SOUTHEND

PETITIONER: CHILDRESS - KLEIN PROPERTIES

TECHNICAL DATA SHEET
 PETITION NO. 98-97 FOR PUBLIC HEARING

SUBJECT: Administrative Approval for Petition No. 98-97 by Childress Klein Properties, Inc. Tax parcels 123-041-14, 123-041-15-21 and 123-041-23.

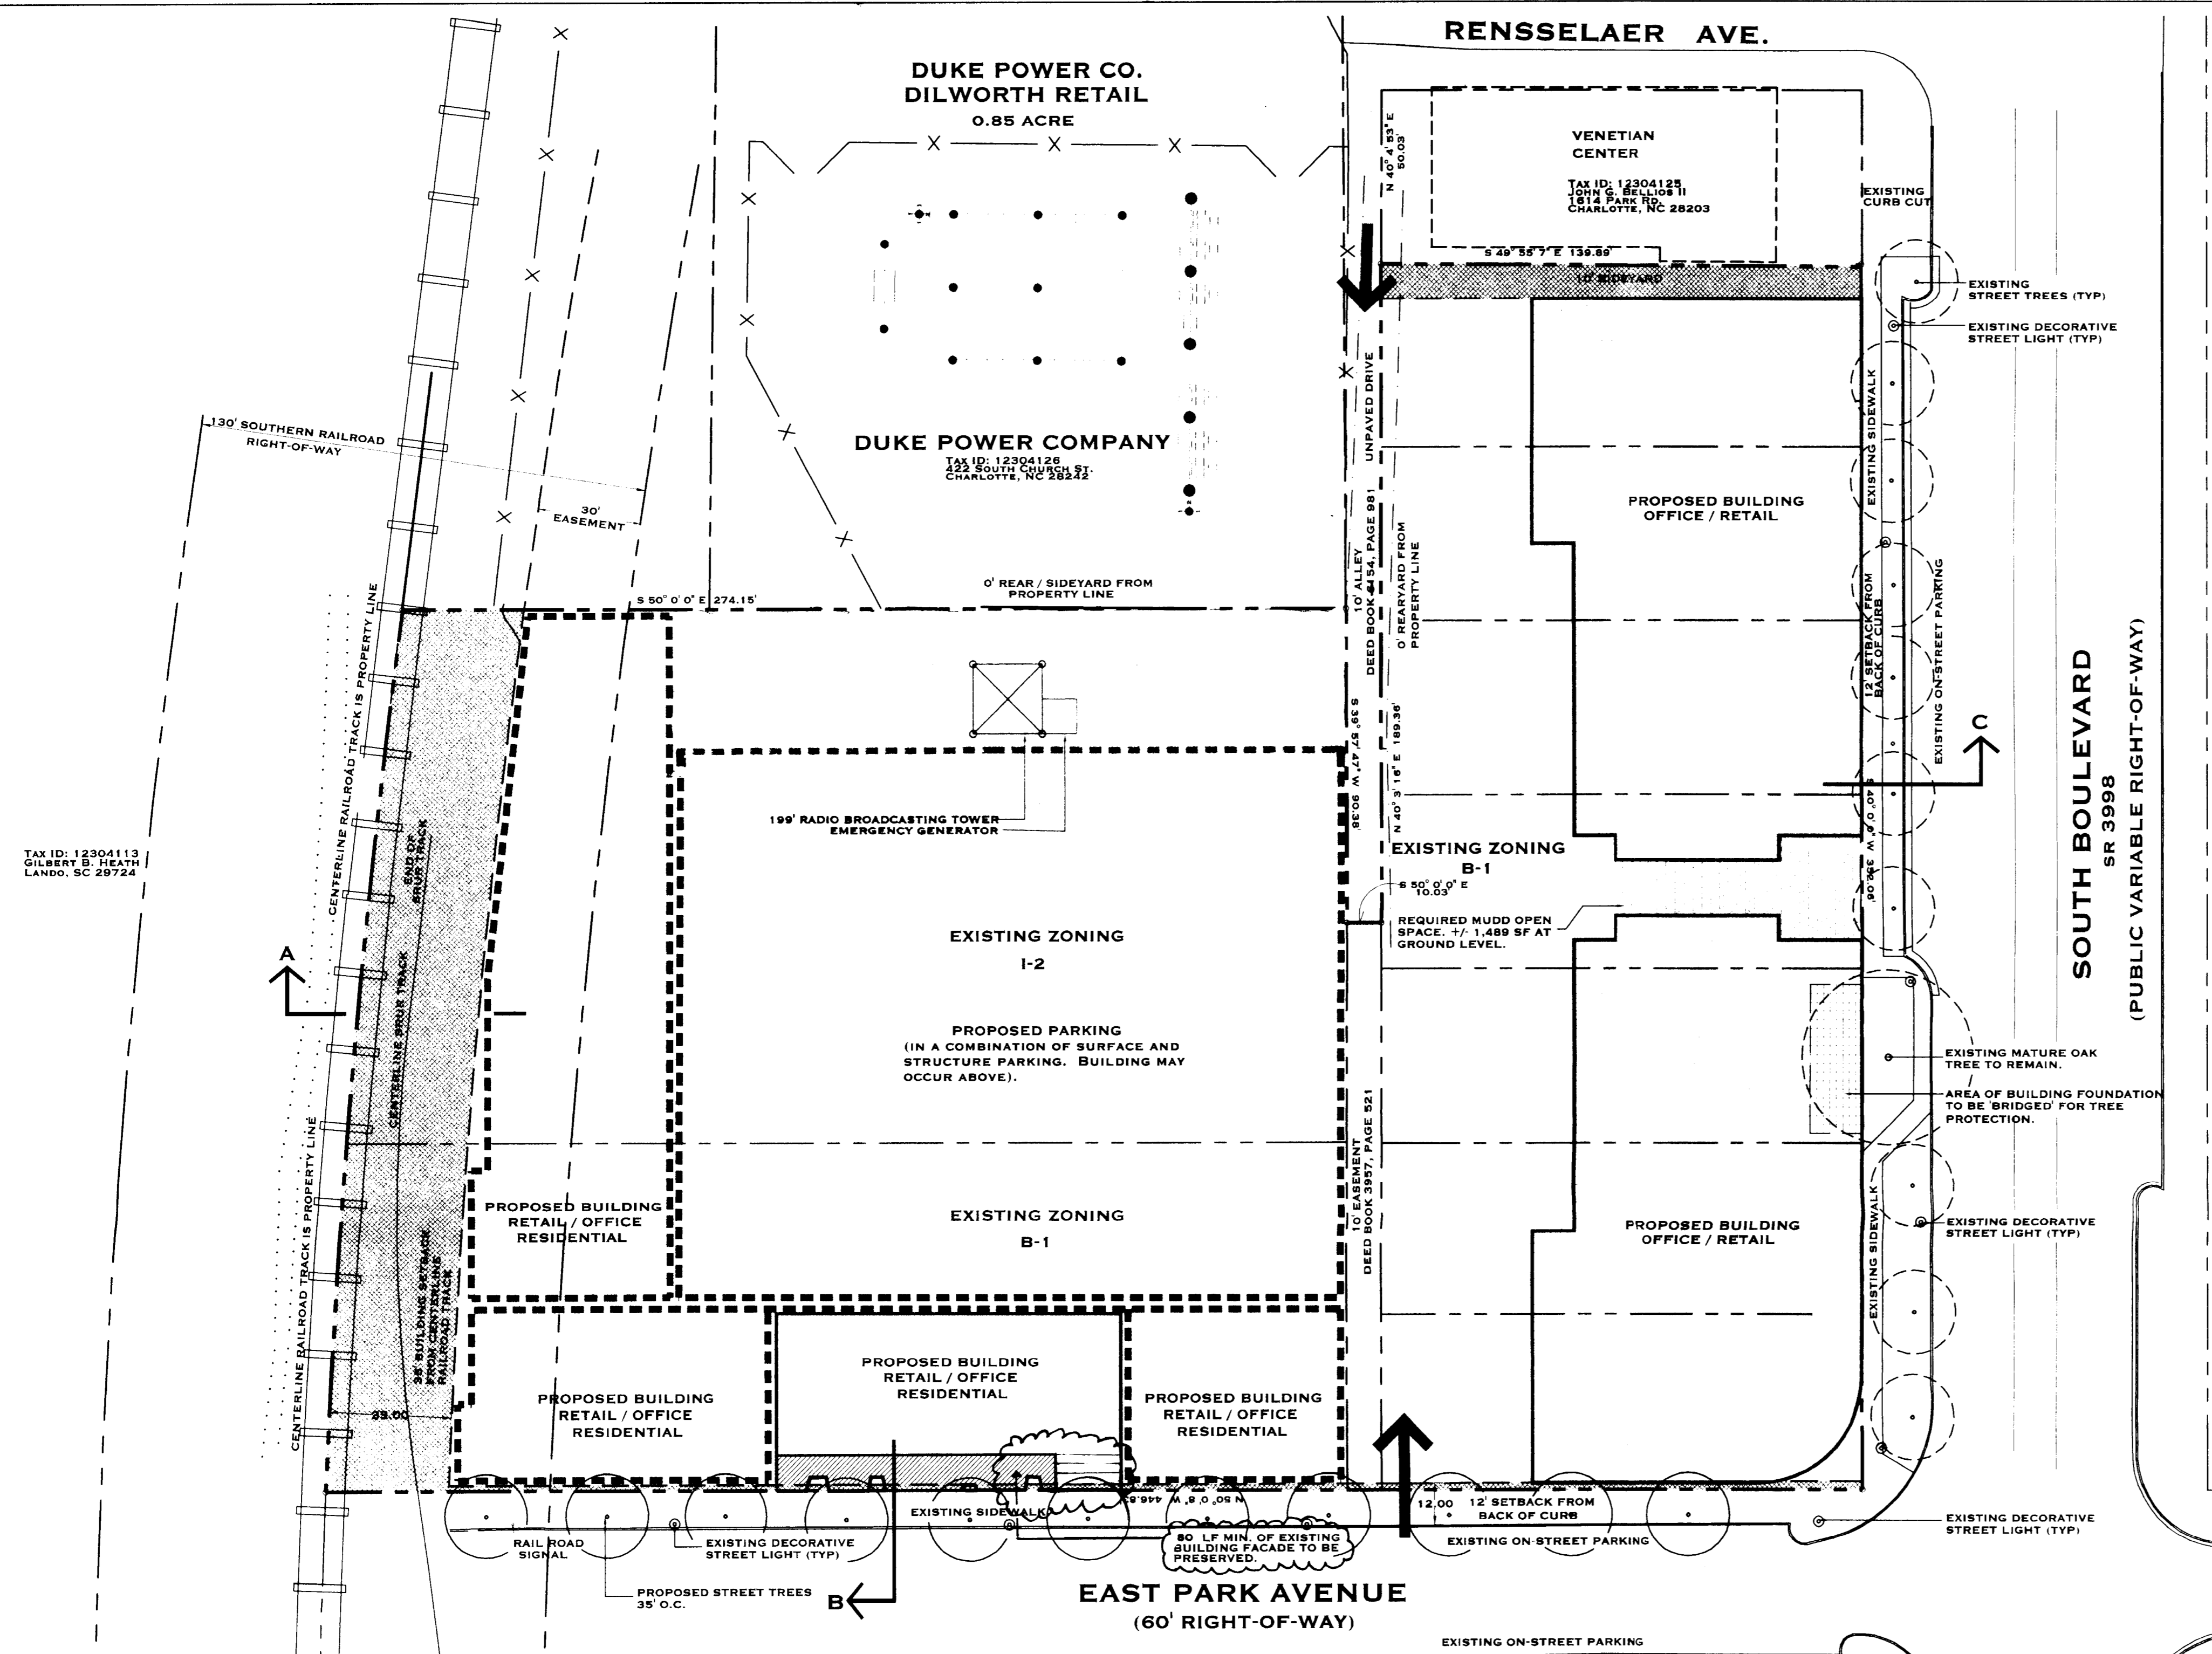
Attached is a copy of the revised plan for the above rezoning petition. The plan has been revised to reduce the amount of building facade that will be preserved along East Park Avenue from 100 feet, to 80 feet. Since this change is minor and does not alter the intent of the development, I am administratively approving this revised plan. Please use this revised plan when evaluating request for building permits and certificates of occupancy.

Existing Structures
 The existing structures on the site shall be razed, except for the preservation of 80 LF minimum of building facade along East Park Avenue as shown on the plan.
